Title: Valve train damage repair procedure on 2004 - 2009 I6 Engines

Applies To: International DT 466, HT 466, DT 570, HT 570 diesel engines (2004 - 2006 MY) serial number range: 2000001 through 2999999.

International® MaxxForce® DT, 9, and 10 diesel engines (2007 - 2009 MY) serial number range: 3000001 through 3299999.

Figure 3: Knicks and burrs at top and inside lifter bore.

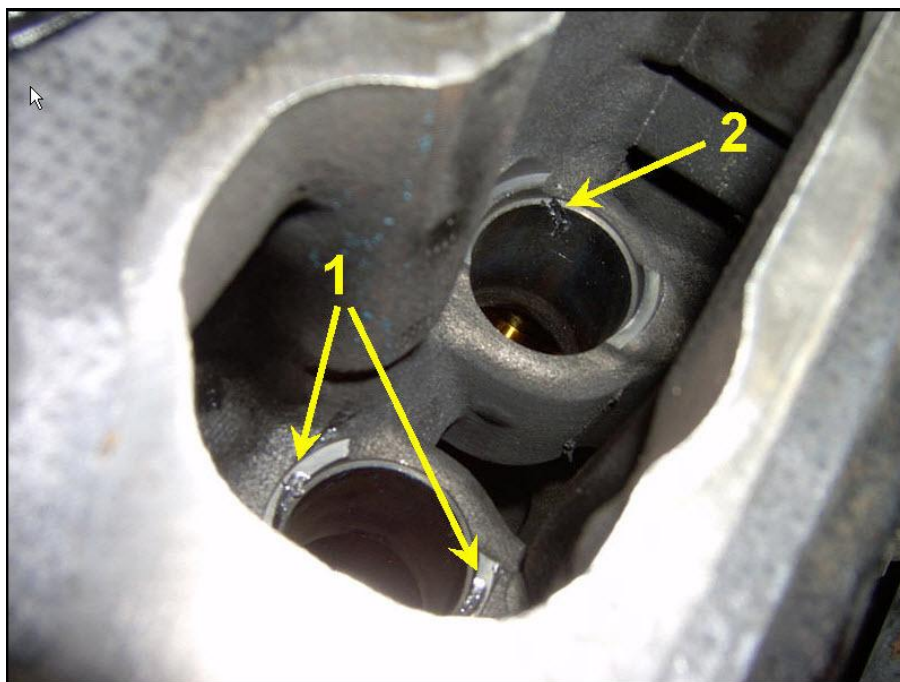
Q. I see damage at the top side of the lifter bore. Do I need to replace the block? (*Figure 3, Item 1*)

Q. The lifter bushing is nicked. Can I replace the bushing or should I replace the block? (*Figure 3, Item 2*)

A. No, block replacement is not necessary. The lifter retainer does not come to contact with the block. It floats between the two lifters. The surface at the top of the lifter bore is machined during the manufacturing process and plays no role in lifter or retainer operation, and no role in engine operation.

A. The bushing is not serviceable and a block replacement is not necessary. A knick or burr to the lifter bushing may be cleaned up by hand with very fine emery cloth. Wash all surfaces very well from abrasive residue and lubricate bore and lifter with engine oil. Install lifter inside bore and move by hand to ensure it doesn't stick or hang to ensure smooth operation.
